Corrigendum III (Replies to Pre-bid Queries)

Name of Project: Design and Construction of Underground Stations at Budhwar Peth, Mandai and Swargate and Associated Tunnels on the North-South Corridor of Pune Metro Rail Project.

Tender No.: P1UGC-02/2018

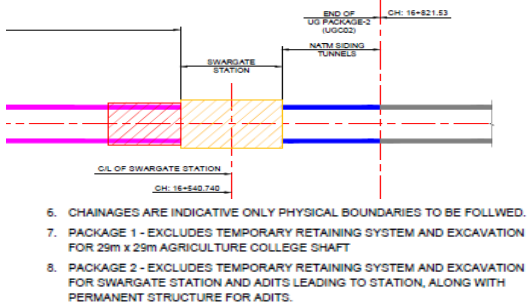
210.	Part 2 - Section VII - Outline Design Specifications S.03-Geotechnical, Bored and NATM Tunnels	3.4.1 General	(1) The Contractor shall be responsible for the control of all ground movements and distortions and for any resulting damage to EBS. During the Preliminary Design phase, the Contractor shall investigate all EBS that may be influenced by the Works and establish allowable movement and distortion	As per clause D (9), Section VI - Employers Requirement Section D - Construction, it is mentioned "Prior to commencing any work within the zone of influence measured 50m from center line of twin tunnel and twice the depth of cut & cover excavation from the periphery of permanent wall structure, the Contractor shall complete a pre-	ER clause D (9) shall be followed. Influence zone beyond the 50m as mentioned in above clause shall be based on settlement analysis.

Sl. No	Volume No	Clause No	Bid Condition	Bidder's Queries	Responses / Replies
			criteria for each individual or group of EBS. The Contractor's EBS study shall extend to a certain distance beyond the potential influence zone (Refer Employers Requirement - Construction, Section D (9)) on each side of the tunnel alignment centreline and also to a certain distance beyond the potential influence zone on each side of the station alignment centreline. The respective influence zones and the distances beyond these influence zones, where EBS study shall have to be conducted by the Contractor, shall be proposed by the Contractor with the required backup details during the Preliminary Design Phase for the acceptance of the Engineer.	<p>construction survey to identify and record any existing defects in the building structure and fabric."</p> <p>Please clarify Building Condition Survey shall be done 50m from center line of each tunnel or from the center line of two tunnels (Alignment center line).</p> <p>As per referred clause 3.4.1, EBS Study shall be conducted till a certain distance beyond potential zone of influence. In case zone of influence will be more or less than 50m as mentioned in clause D (9), Section VI - Employers Requirement Section D - Construction, which distance shall be considered for Building Condition Survey? Also, please clarify the certain distance beyond the potential zone of influence mentioned in said clause.</p> <p>We understand zone of influence shall be derived by settlement analysis. Please confirm.</p>

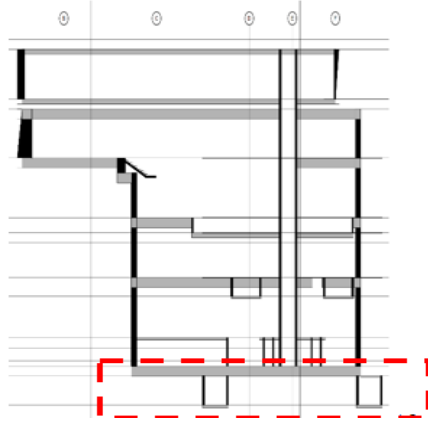
667.		BOQ-PART-A ELECTRICAL WORKS FOR CIVIL COURT	Cables	Kindly clarify below mentioned points:- 1. Kindly mention specifically which standard is applicable for LT cable i.e. IS	Please read specifications in conjunction with revised BOQ in Corrigendum.

Sl. No	Volume No	Clause No	Bid Condition	Bidder's Queries	Responses / Replies
		STATION - Sr. No.E.03.01		7098-1 or BS 6724 and mention the same in attached BOQ for each part . 2. In attached specification clause no 5.4.3.10 copper tape shielding is required in XLPE cable and control cable whereas in attached BOQ it is not mentioned anywhere. Kindly specify the requirement of copper shielding in LT cable, whether required or not? 3. If, copper shielding is required then as per details mentioned below kindly clarify the location of copper shielding in cable. Whether, it is required over laid up core or above inner sheath. Kindly clarify. 4. Kindly specify the armour requirement in BOQ for each part. Whether required or not.

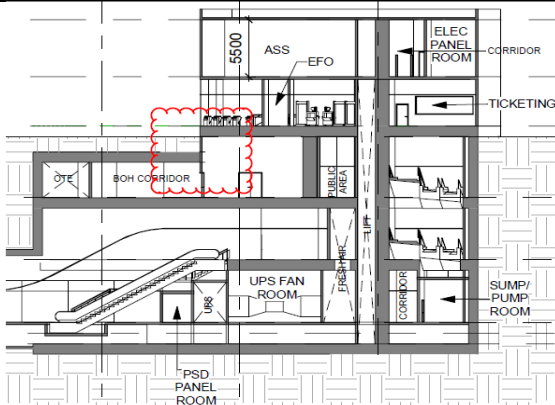
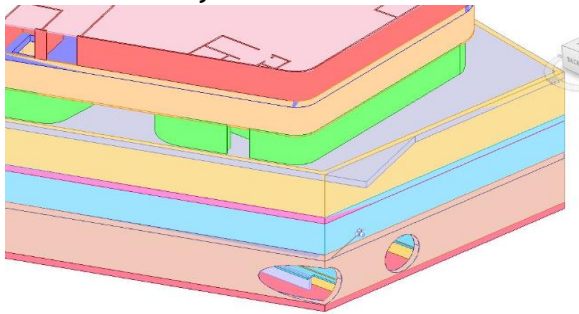
672.		BOQ Price Center I	Price breakdown structure	Price breakdown structure of BOQ Price Center I summary Part A (Electrical Works) is not clear. If abow mentioned items will	Please refer corrigendum - Annexure 10.

Sl. No	Volume No	Clause No	Bid Condition	Bidder's Queries	Responses / Replies
				include amount of their subitems, then please confirm that "Electrical Works" amount should exclude the amount of those mentioned subitems due to aware of amount duplication.
